# Service Bulletin

Bulletin No.: 24-NA-133

**Subject: Wheel Drive Shaft Retention Snap Ring Design Change**

Service Groove (New Design)

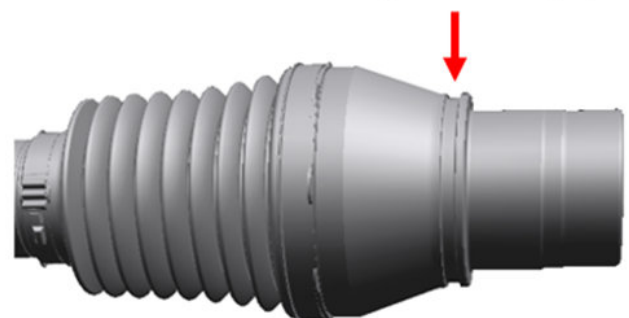
The design change occurred to achieve greater retention forces between the wheel drive shaft and the drive unit output stub shaft.

The easiest way to know if the vehicle was built with a round snap ring vs. a 3-point oval snap ring is by looking for the presence of a service groove on the wheel drive shaft as shown below.

**3 Point Oval Ring Second Design: PN 24052327**

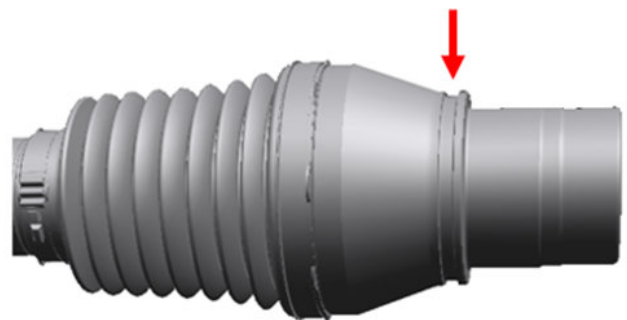
When servicing the vehicle, if the wheel drive shaft is removed or replaced, care must be taken to determine which snap ring is present. The round (silver) snap ring is considered the first design (Des 1), and the 3-point (black) oval snap ring is considered the second design (Des 2). Refer to the Electronic Parts Catalog for Design 1 and Design 2 designations.

With the snap ring removed, lay the snap ring on a flat surface, and look at the shape of the snap ring.

**Important:** The snap ring MUST ALWAYS BE REPLACED when removing or replacing the wheel drive shaft.

NO Service Groove (Old Design)

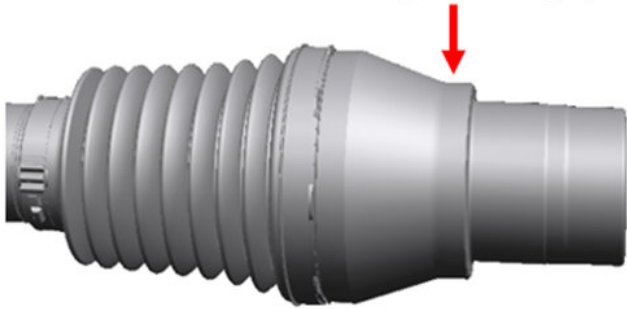
NO Service Groove design uses the 1st design  
Round Snap Ring PN 24048716
